Long Wittenham Parish Council

SODC Planning Department
Application P16/S1124/O Land Adjacent Fieldside
For the attention Amanda Rendell

Highway Records Plan showing ditch is not part of the Highway

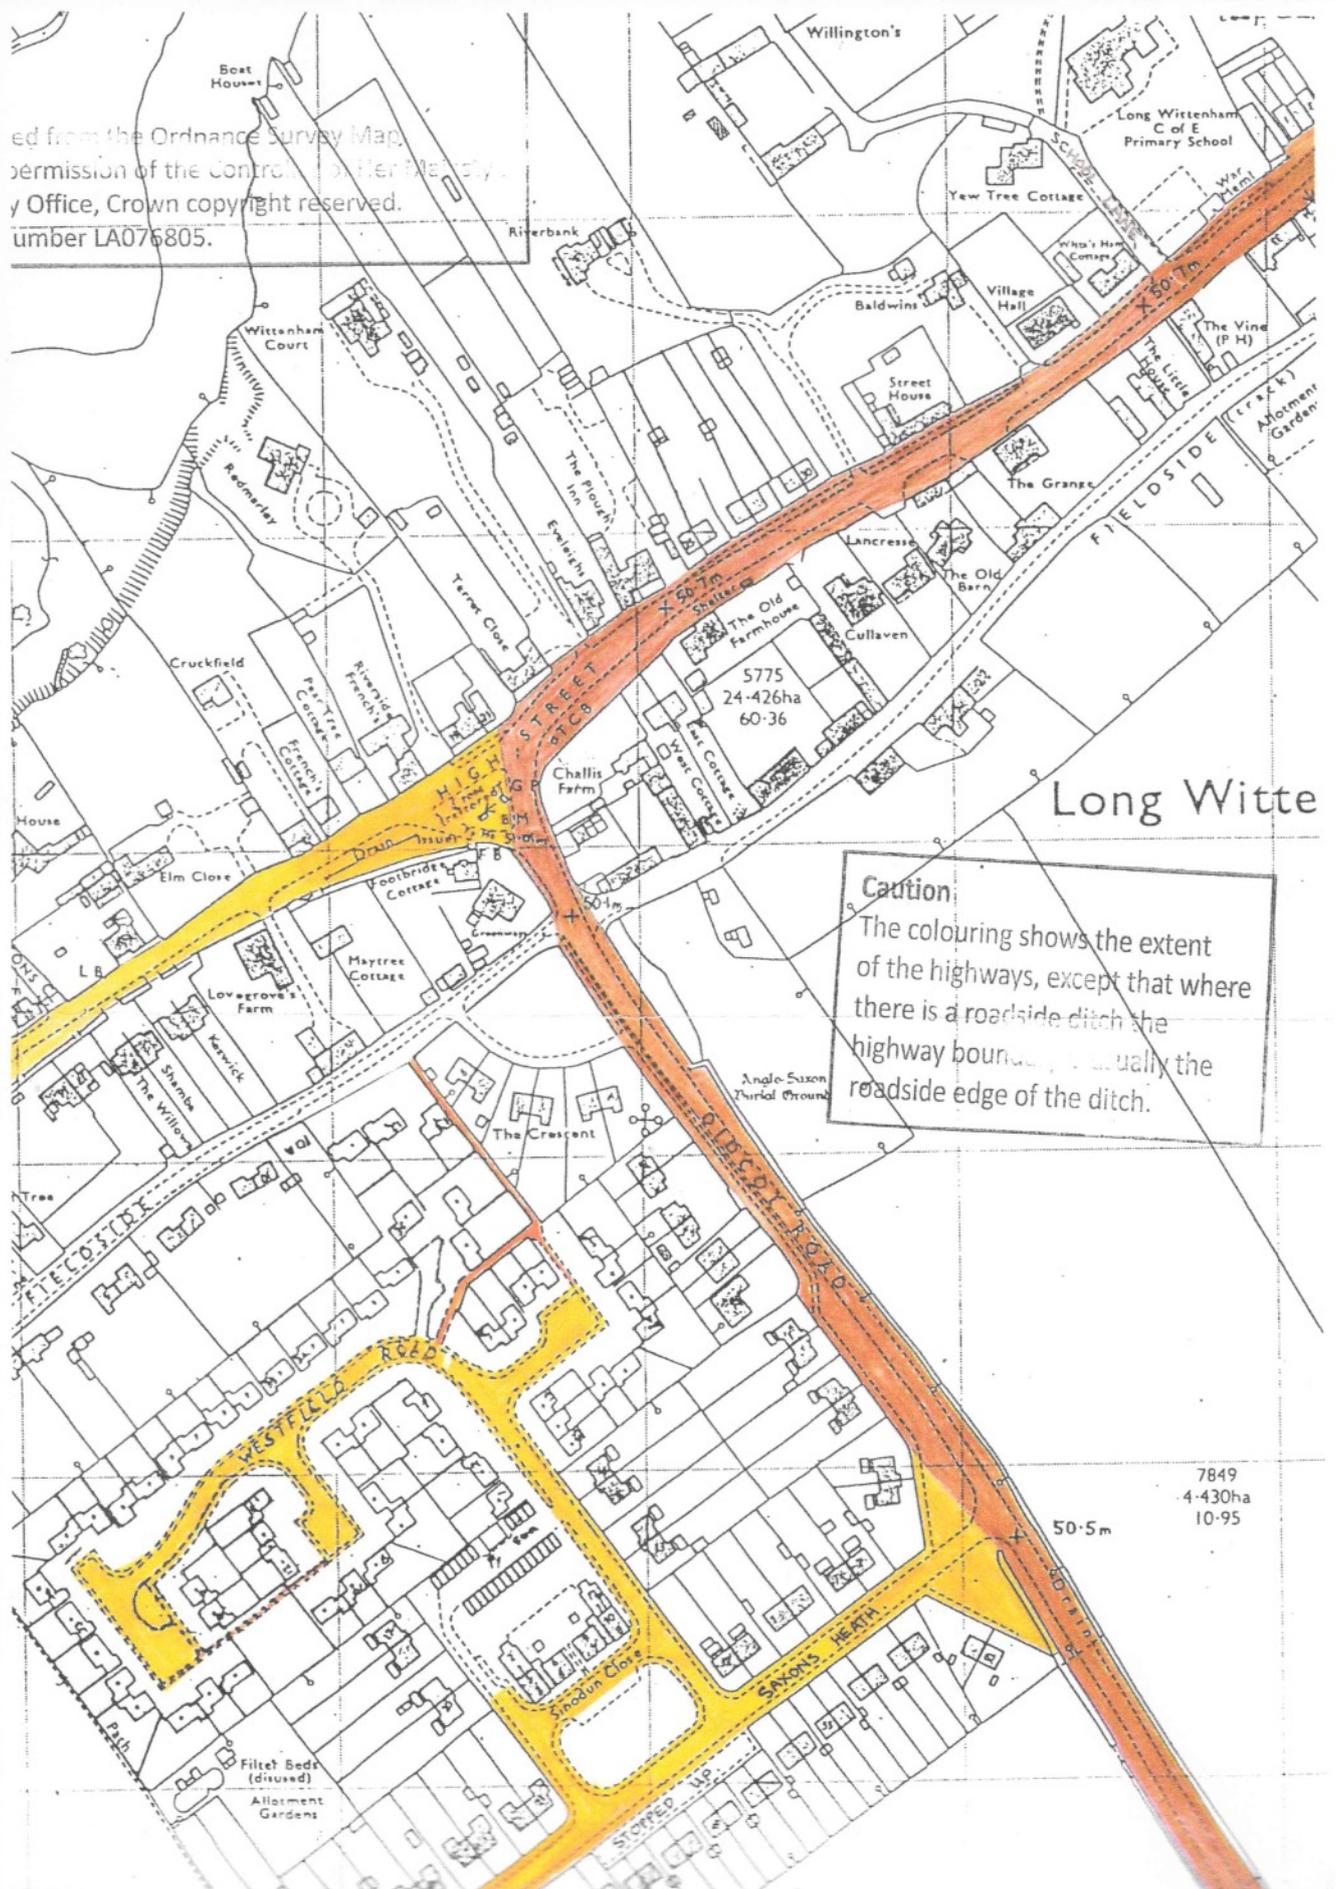
Our view is based on correspondence and a copy of the highway records provided by OCC (and which we assume under due diligence the Kler highways consultants would also have obtained) that the limit of the highway is the front edge of the ditch.

This is clearly shown on the highway records (plan below) and concurs with a judgement by Lord Denning Master of the Rolls that roadside ditches are not part of the Highway.

The Applicants topographical survey shows the ditch less than 1m from the road edge which we agree having checked on site. However their independent Road Safety Audit (RSA) "assumes" the extent of the highway is the centre of the hedge which is some 2m plus behind the ditch. The RSA, based on this assumption, states that the vision splays

can be achieved but this is **not** the case because they encroach on land in 3rd party ownership. This is explained by reference to both the OCC Highway records and the Land Registry plans attached below.
